**City of Charlottesville
Board of Architectural Review
Regular Meeting
May 17, 2022, 5:30 p.m.
Hybrid Meeting (In-person at CitySpace and virtual via Zoom)**

- 1. [Meeting minutes August 17, 2021](#)**
- C. Deferred Items**
 - 2. [Certificate of Appropriateness](#)**
BAR 21-10-04
310 East Main Street, TMP 28004100
Downtown ADC District
Owner: Armory 310 East Main, LLC
Applicant: Robert Nichols/Formworks
Project: Facade renovations/alterations

- 3. [Certificate of Appropriateness](#)**
BAR 10-11-04
123 Bollingwood Road, TMP 070022000
Individually Protected Property
Owner: Juliana and William Elias
Applicant: Jeff Dreyfus, Bushman Dreyfus Architects
Project: Modifications to the west elevation

Proposed November 2021

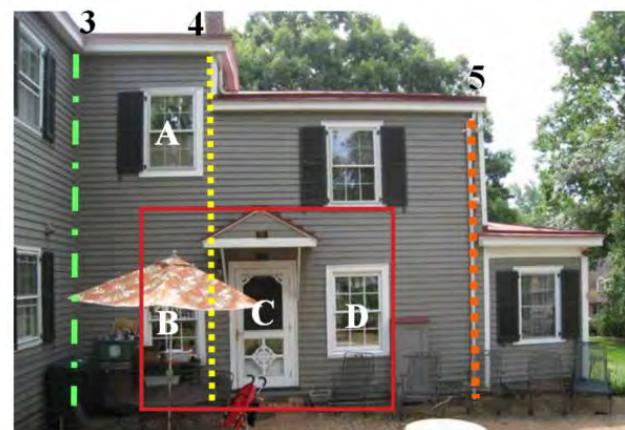
Request CoA to modify the west elevation of the rear addition: New sliding door and exterior stoop at the door. (The landscape plan, including other work on the property, is aspirational and included in the submittal for context only.) Note: In November 2021, the BAR reviewed a conceptual sketch of the proposed changes. See the Appendix.

Modifications to the west elevation: The existing door and window to the left (in the photos and elevations) are not in the historic photos and were added after/during construction of the small addition to the SW corner of the main house. (See the comparison photos in the Appendix.)

ELEVATION CONCEPT

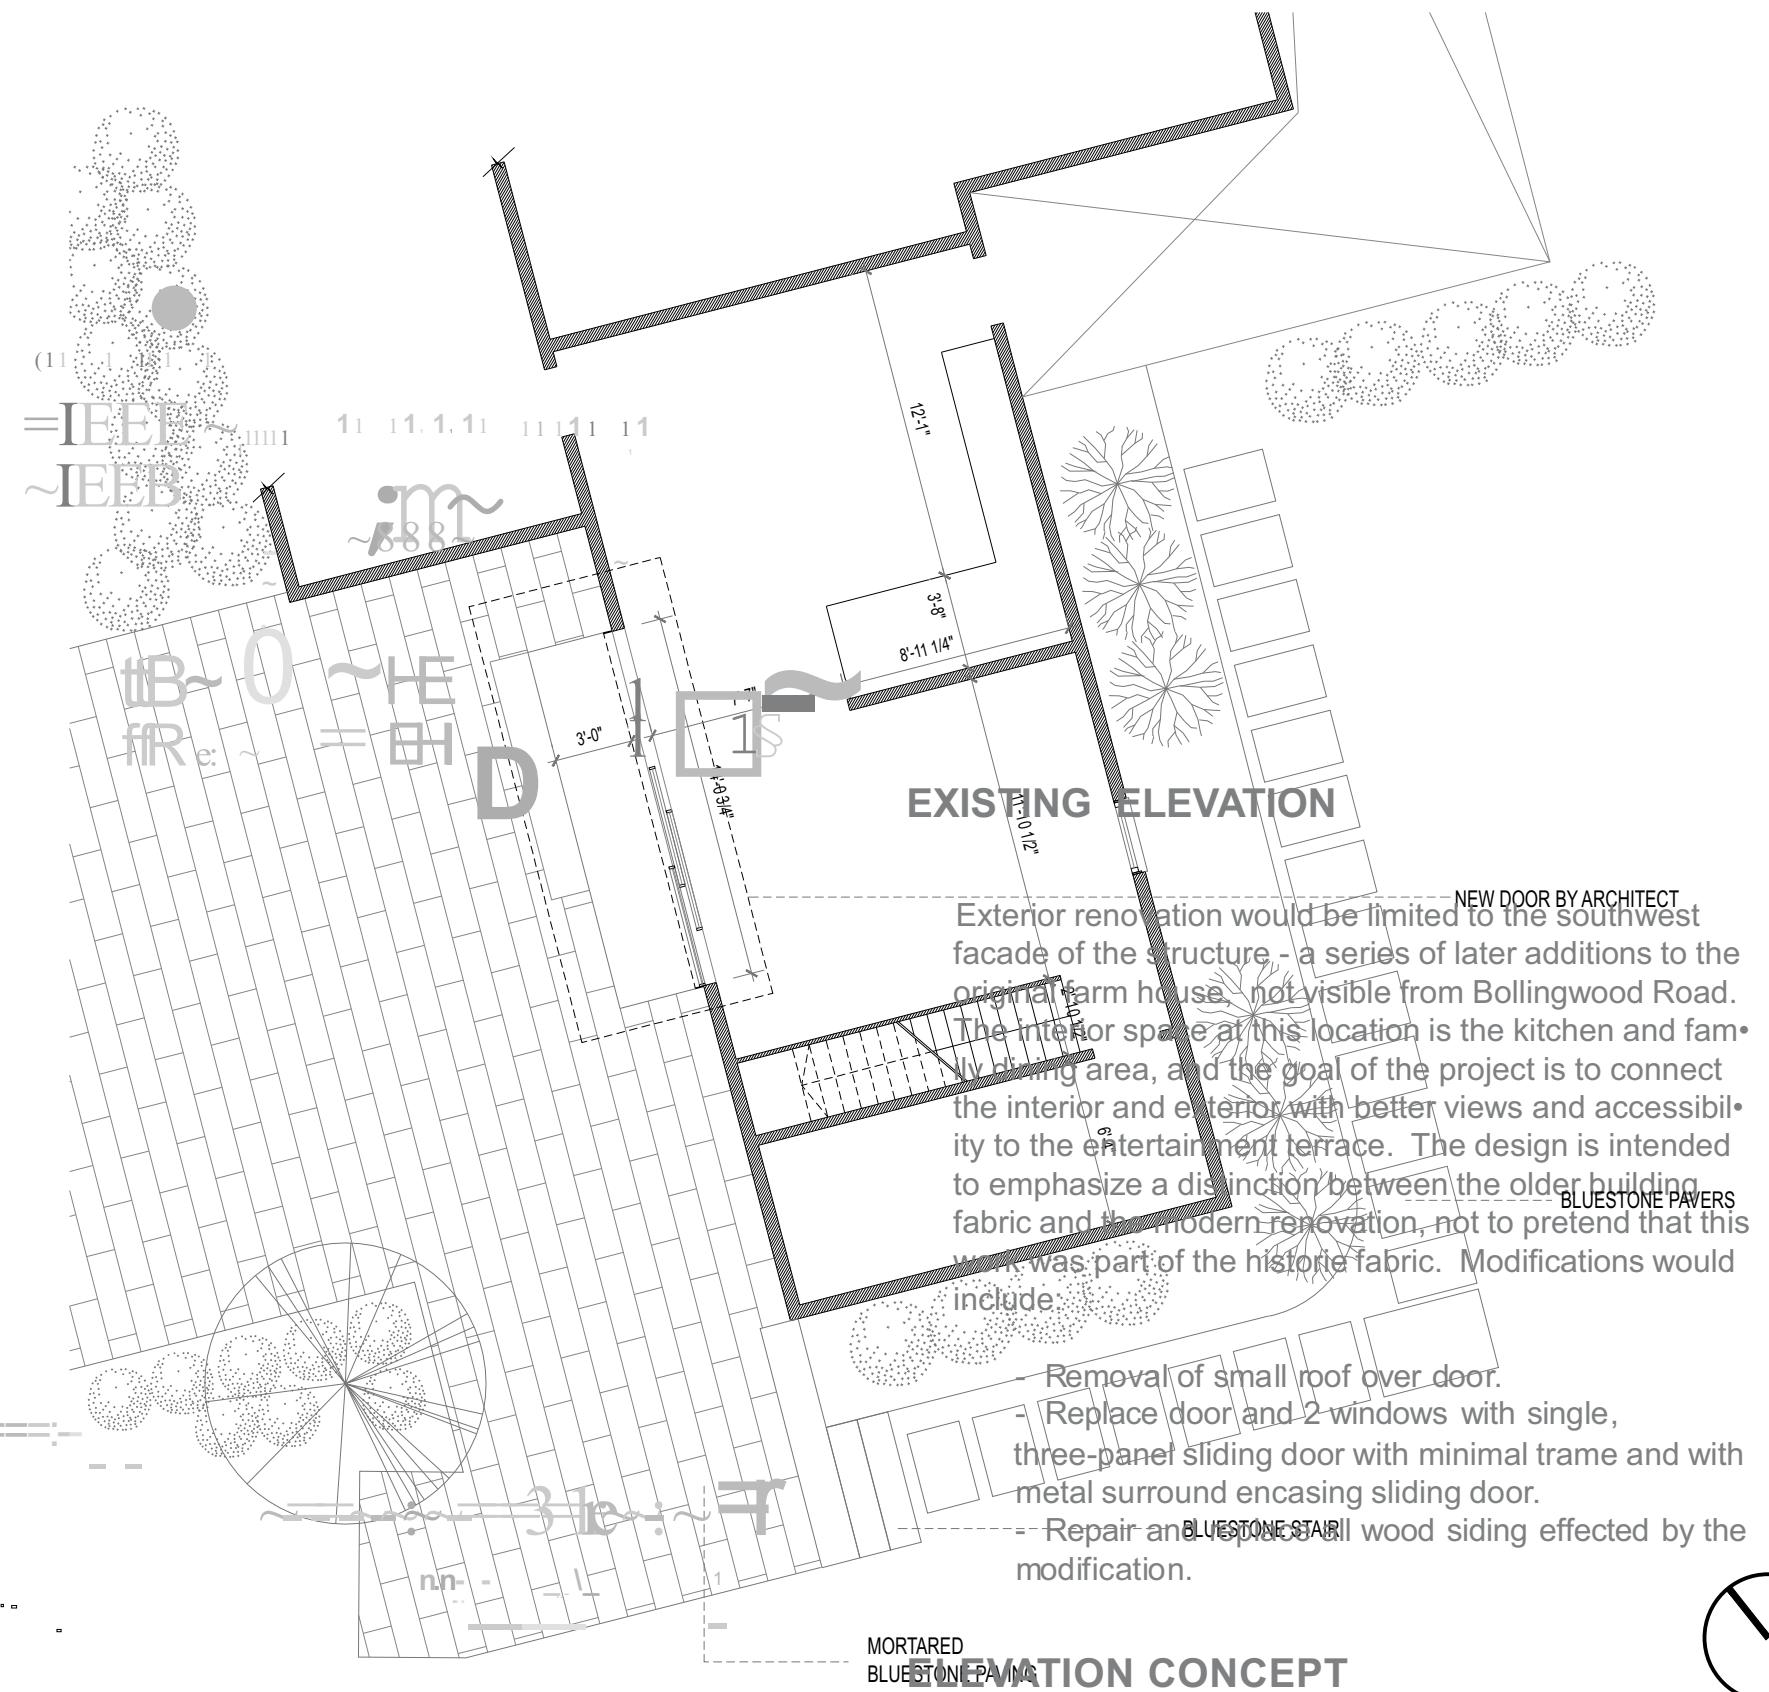
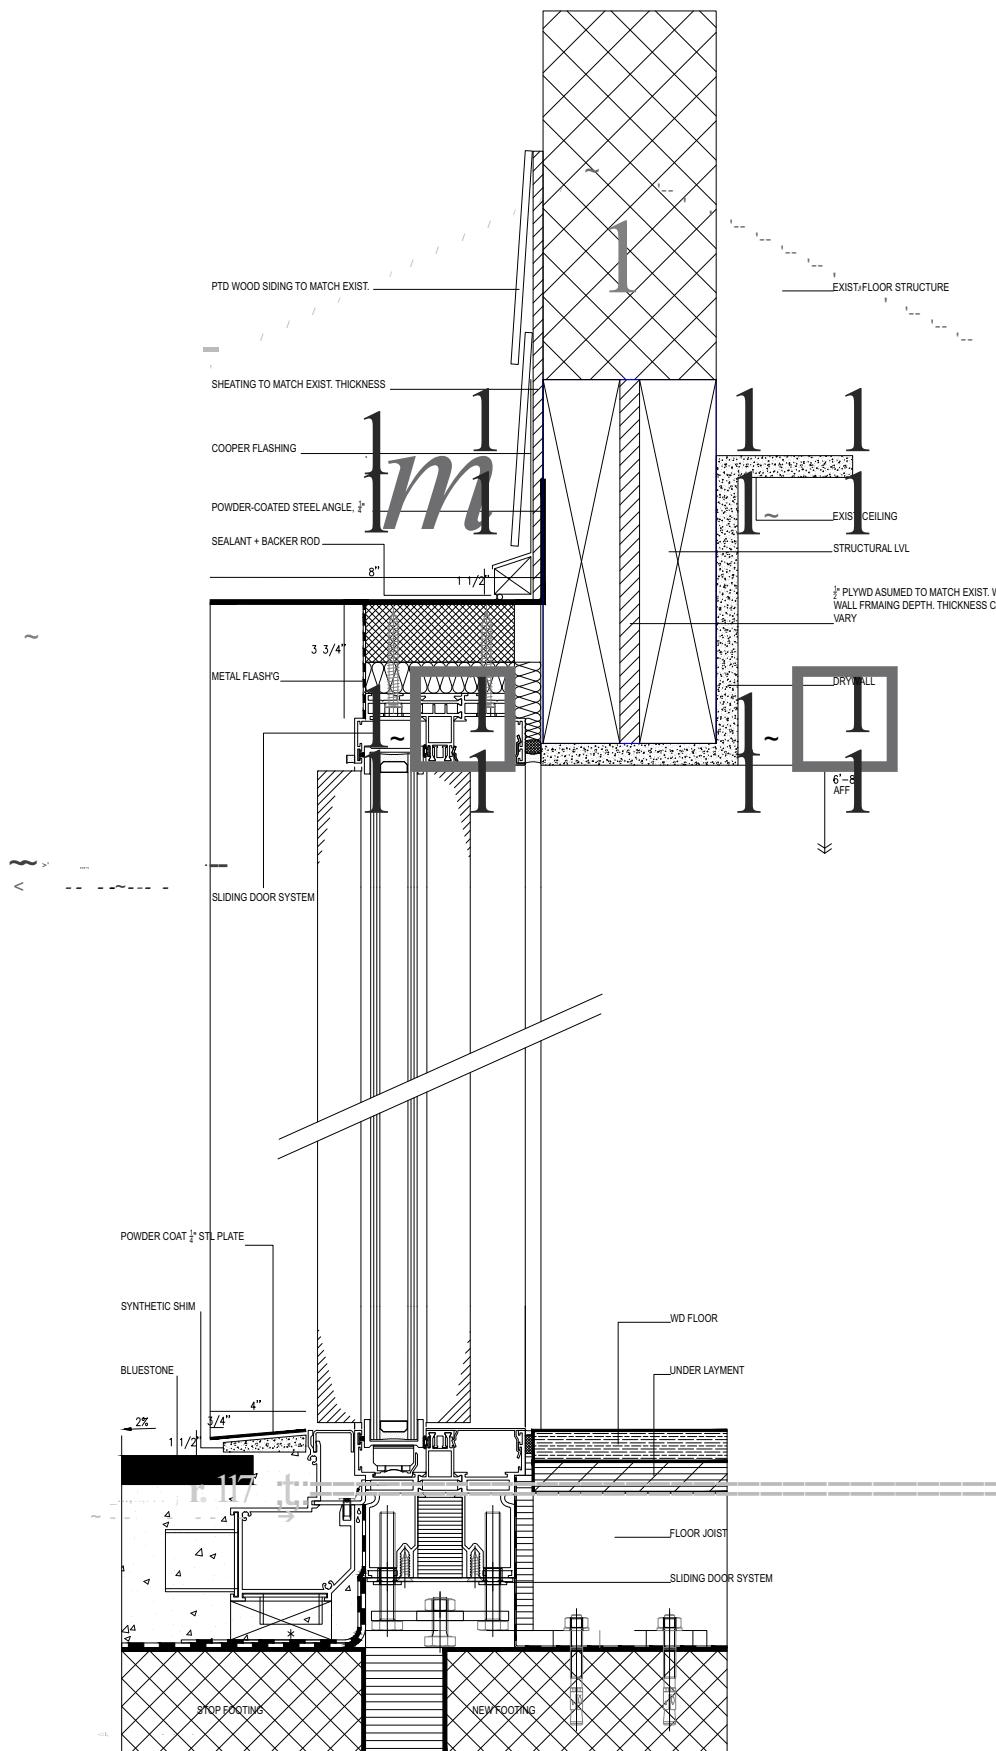
Exterior renovation would be limited to the southwest facade of the structure - a series of later additions to the original farm house, not visible from Bollingwood Road. The interior space at this location is the kitchen and family dining area, and the goal of the project is to connect the interior and exterior with better views and accessibility to the entertainment terrace. The design is intended to emphasize a distinction between the older building fabric and the modern renovation, not to pretend that this work was part of the historic fabric. Modifications would include:

- Removal of small roof over door.
- Replace door and 2 windows with single, three-panel sliding door with minimal frame and with metal surround encasing sliding door.
- Repair and replace all wood siding effected by the modification.
